Request for Additional Information
Model No. Traveller
Docket No. 71-9297

By application dated April 1, 2004, Westinghouse Electric Company requested a Certificate of Compliance for the Model No. Traveller package. This request identifies additional information needed by the Nuclear Regulatory Commission staff (the staff) in connection with its review of the safety analysis report (SAR). The requested information is listed by chapter number and title in the SAR. NUREG-1609, "Standard Review Plan for Transportation Packages for Radioactive Material," was used for this review. This request describes information needed by the staff for it to complete its review of the SAR and to determine whether the applicant has demonstrated compliance with regulatory requirements.

Figure 2-1A Sample of Clamshell Accelerations Measured During Road Test (May 11, 2004)

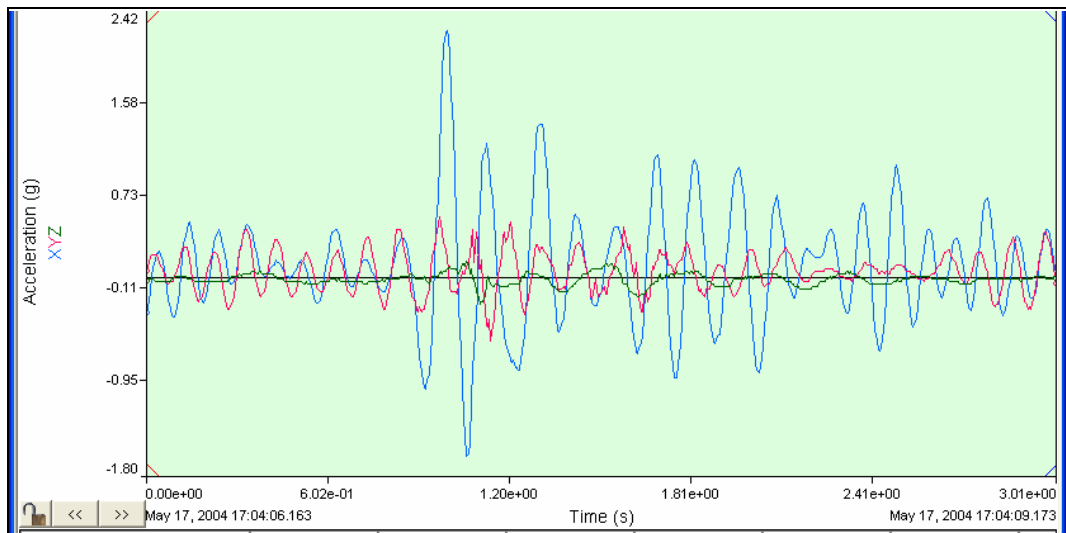
- 2-3 Revise Section 2.6.5 to include an evaluation of vibration frequencies of the Clamshell-shock mount system to ensure that no resonant vibration conditions could occur yet result in damage to the Clamshell and its contents during normal conditions of transport.

The following text and figure have been added to Section 2.6.5:

There are several natural frequencies of the shock mount system depending on direction of movement. The dominant frequency is for vertical movement. This frequency is between 5.9 and 6.7 Hz (for Traveller XL) depending on the weight of the fuel assembly being transported. The fore and aft pitch frequency is slightly higher (6.9-7.9 Hz) but has a lower amplitude. Road tests have been performed with the suspension system to measure amplitudes during shipping. Figure 2-1A is characteristic of the results seen. When the truck travels over a bump, the clamshell initially sees relatively large accelerations (2-3 g's) but this oscillation quickly damps out to accelerations less than 1g. This 300 mi trip involved approximately five and a half hours on the road with 1.4×10^5 total cycles.

Figure 2-1B Impact Limiter "Pillow" Assembly

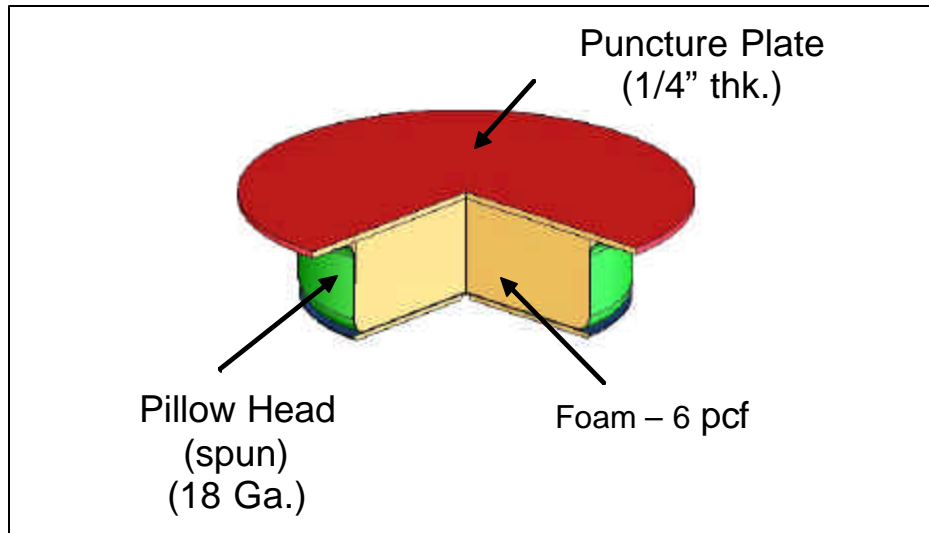
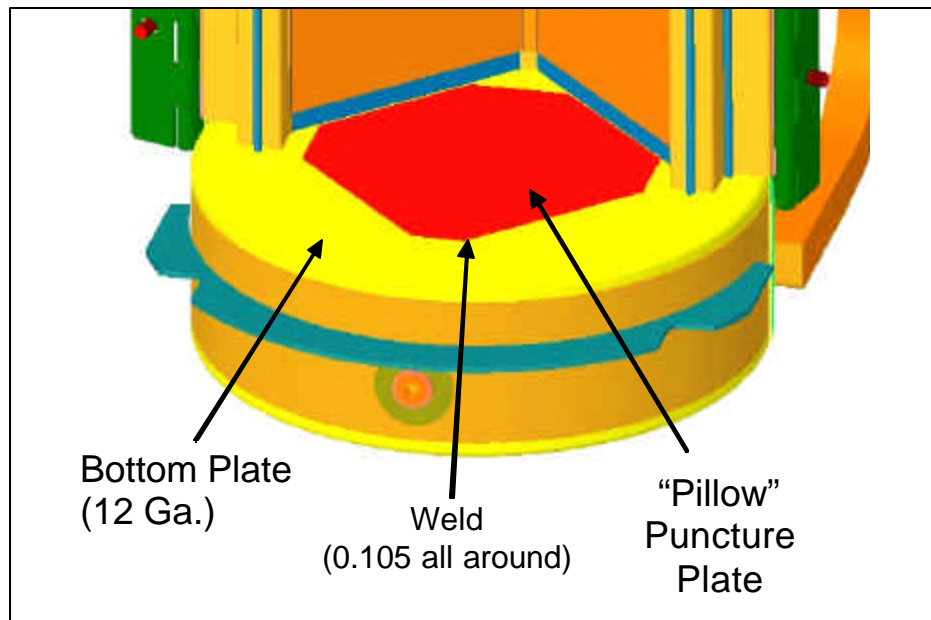
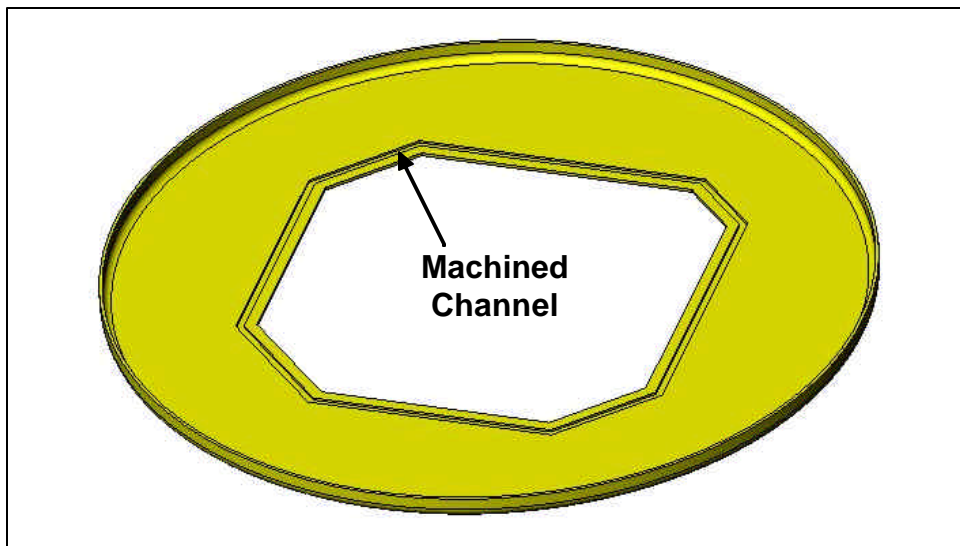
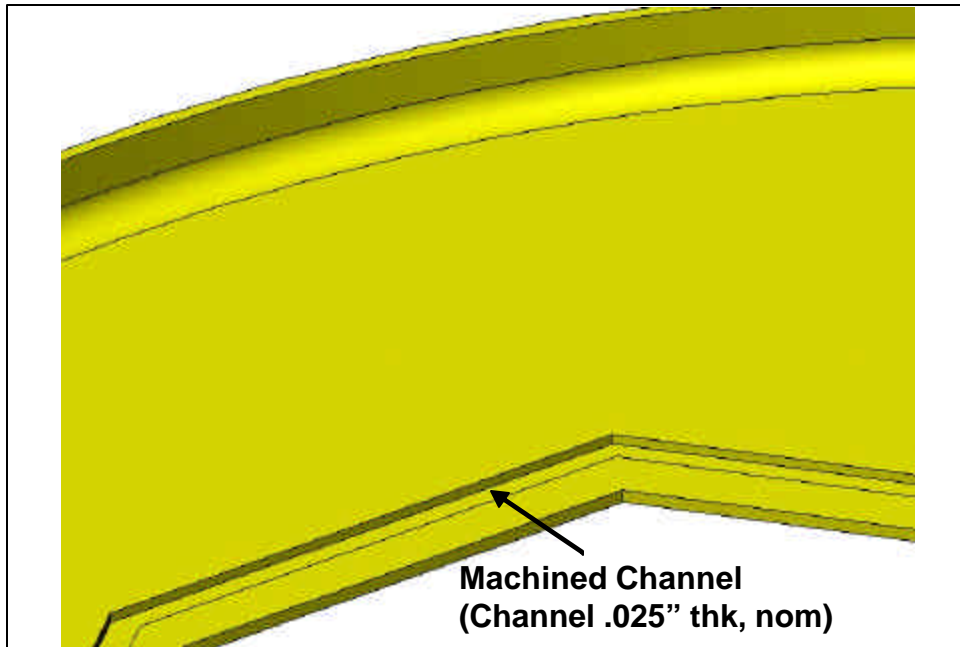
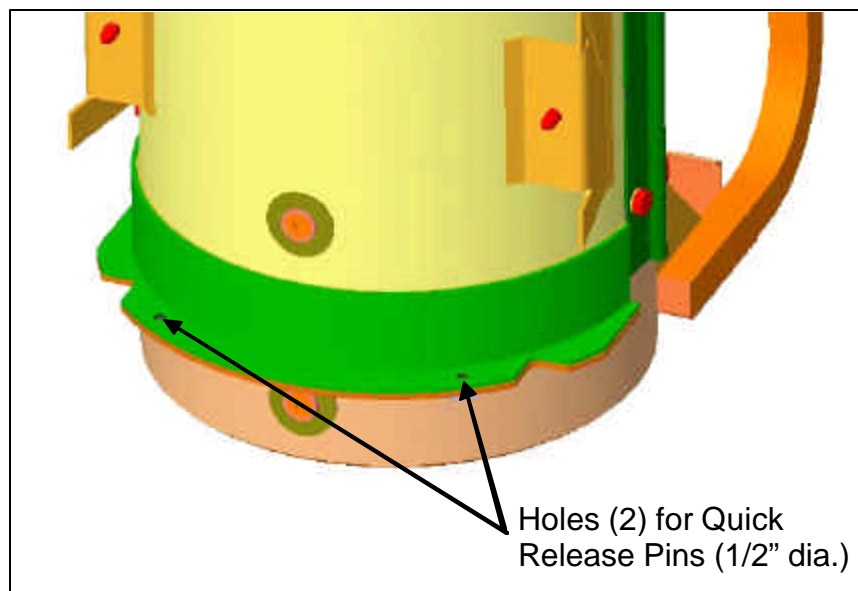
- 2-5 Provide drawing details for the design changes introduced to the Certification Test Unit drop tests to improve performance of the package, including welding of the impact limiter pillow to

the Outerpack liner plate and modification of the quick release pin. Changes to the packaging features that are important to safety should properly be presented in design drawings (Table 2-5, Page 2-22).

The following text and figures have been added to Table 2-5:

The figure below (Figure 2-1B) shows the impact limiter, or Pillow, assembly (shown without insulation). This assembly is shown installed in the Traveller package bottom (the configurations are the same for STD and XL packages) in Figure 2-1C. The weld between the bottom plate (yellow) and the puncture plate (red) is also shown. During testing this weld failed as expected, however, it did not completely allow the components to separate. This design change weakens the bottom plate by reducing its thickness to a nominal 0.025" thickness, as shown in Figures 2-1D and 2-1E. A .25 inch wide channel was added to weaken the part.

The CTU design included a pinned connection (2 quick release pins – 0.5" diameter) between Outerpack halves at the bottom end of the package. Quick release pins were designed to help prevent the halves from warping and opening a gap locally during fire testing. Figure 2-1F shows the location of the quick release pins. During drop testing, the pins failed, therefore, they could not be used in the fire testing.

Figure 2-9 Weld Geometry at Swing Bolt Block

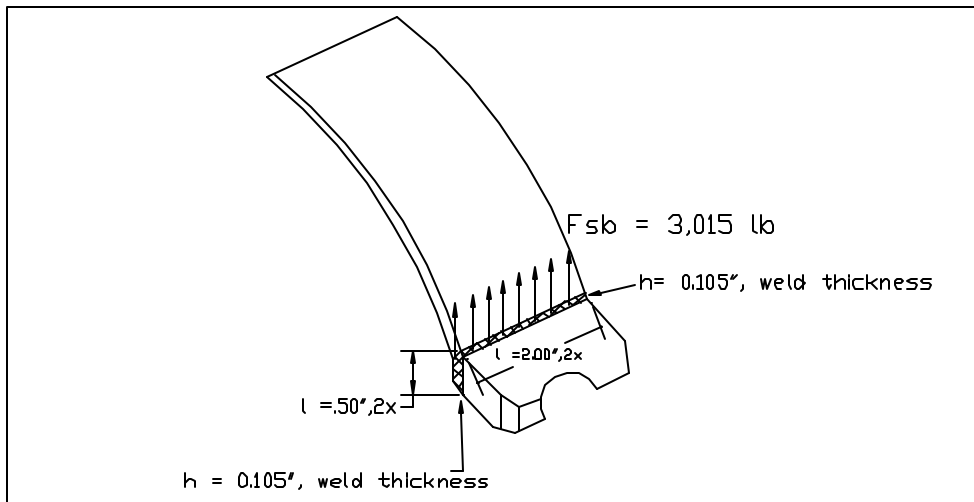
- 2-7 Provide drawing details for the swing bolt block, as identified in Figure 2-9, used for the alternative lifting configuration. The swing bolt block depicted in Figure 2-9 lacks sufficient detail to enable proper evaluation of its structural capacity.

Figure 2-9 has been revised as follows:

Figure 2-100 Outerpack Mesh in Qualification Unit Model

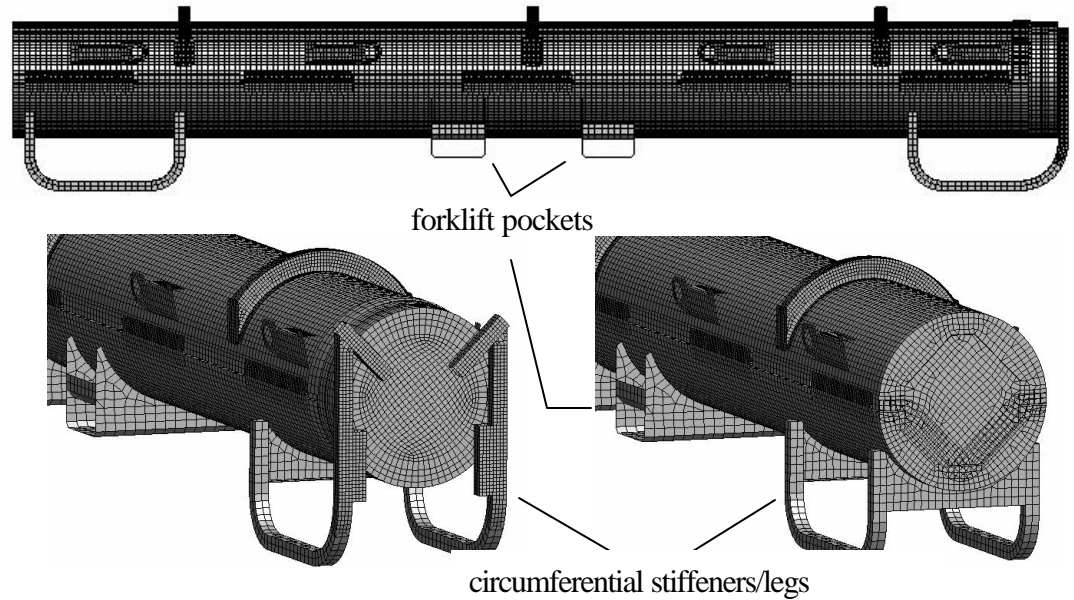
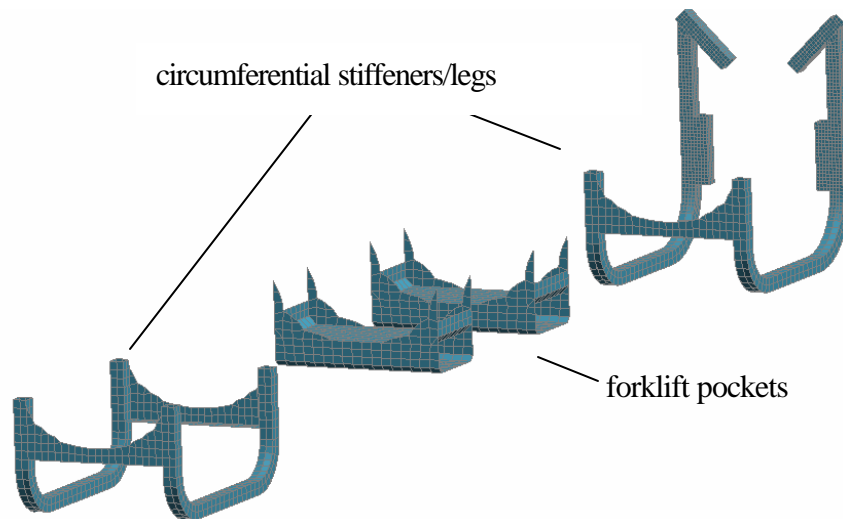
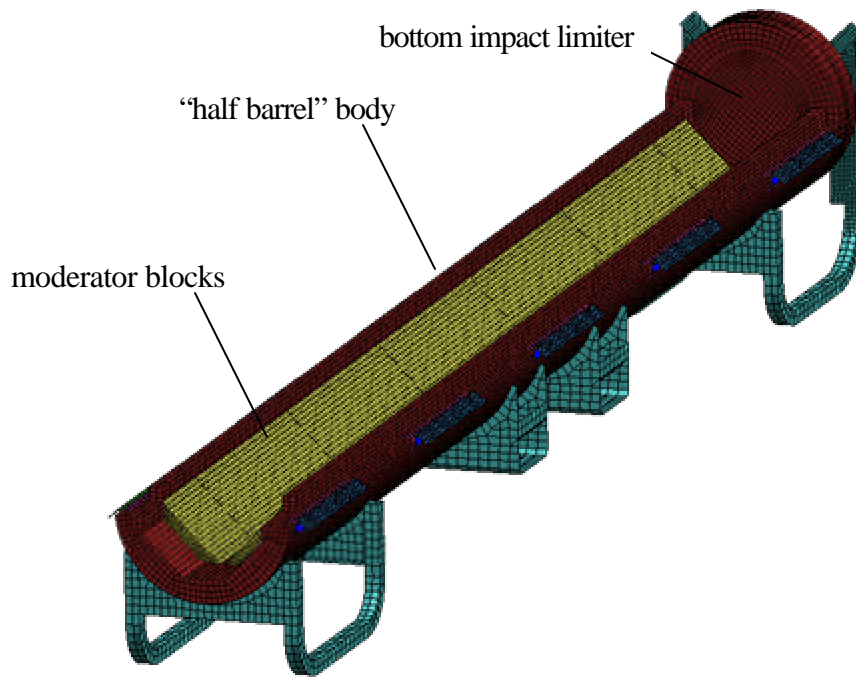
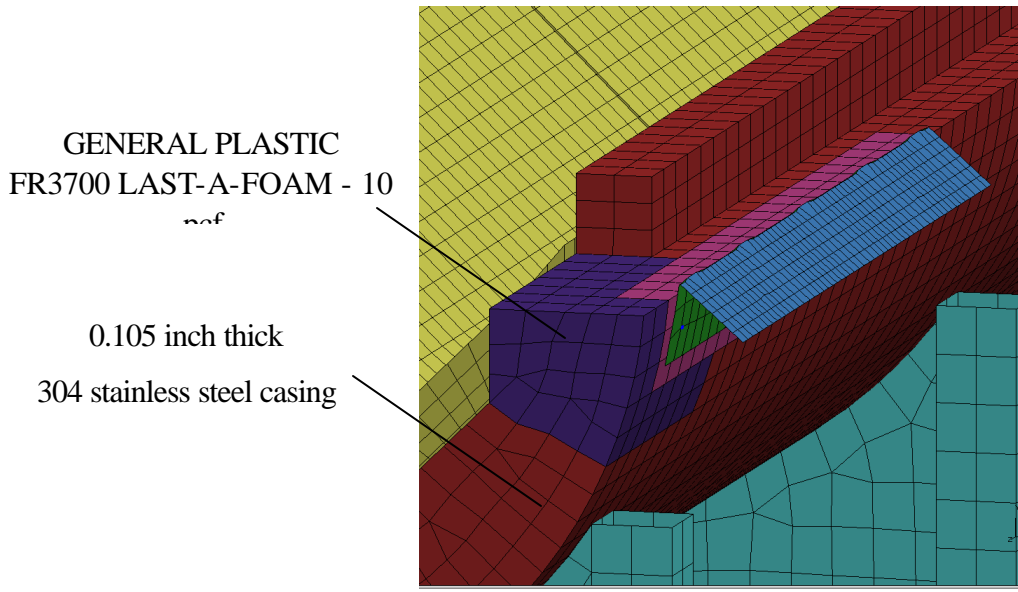
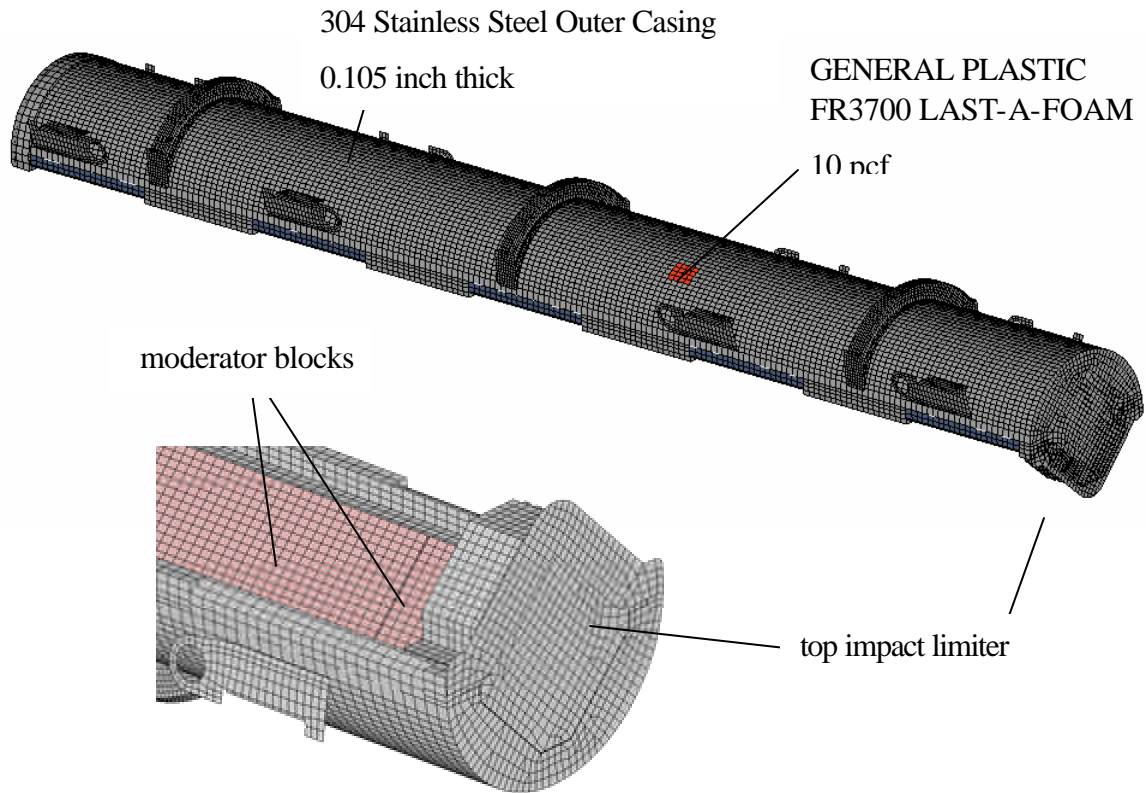
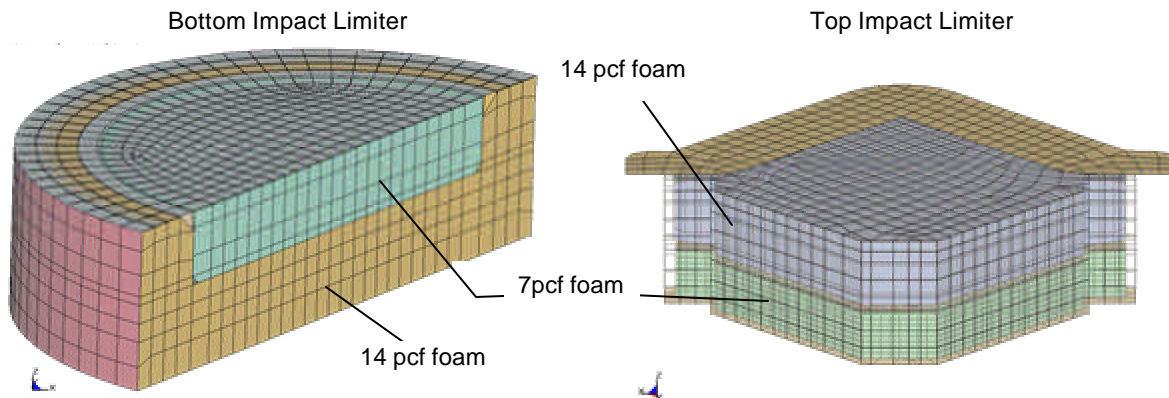
- 2-10 Revise Section 2.12.3, to include illustrations in sufficient detail for the finite element analysis (FEA) models of individual package parts and their interfaces. Also, revise the application to include descriptions of modeling parameters, such as element types, material types and associated state equations, and boundary conditions from which the calculated drop accident responses can be properly evaluated.

Two new sections, Sections 2.12.3.5.4 and 2.12.3.5.5 have been added and the title for Section 2.12.3.6 has been corrected as follows:

The circumferential stiffeners/legs and forklift pockets (Figure 2-100A) were modeled using 4-node Belytschko-Tsay shell elements (LS-DYNA elform = 2). These elements were integrated at three locations through the thickness using Gaussian quadrature. 1,008 of these elements were used to model the forklift pockets and 4,436 were used modeling the legs.

Figure 2-102 Clamshell Mesh in Qualification Unit Model

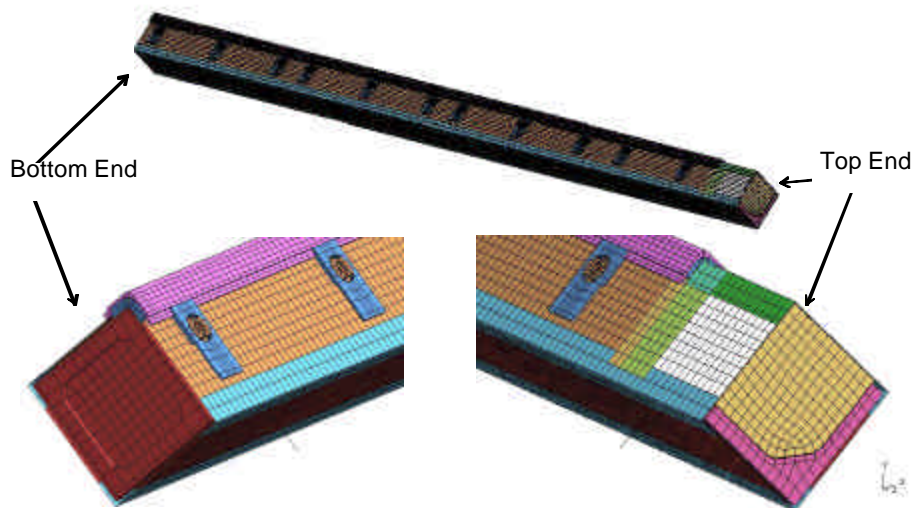
- 2-20 Verify that appropriate finite element Clamshell models were used in the analysis of the Qualification Unit drop test. The staff notes that modeling attributes, including element meshes, are markedly different for the same Qualification Unit Model shown in the two plots, Figures 2-96 and 2-102. It is not clear from the information provided which Clamshell model was used in the analysis.

The clamshell design did evolve during its development. The final design is reflected in Figure 2-102 and all analyses reported in the SAR utilized the clamshell model depicted in this figure.
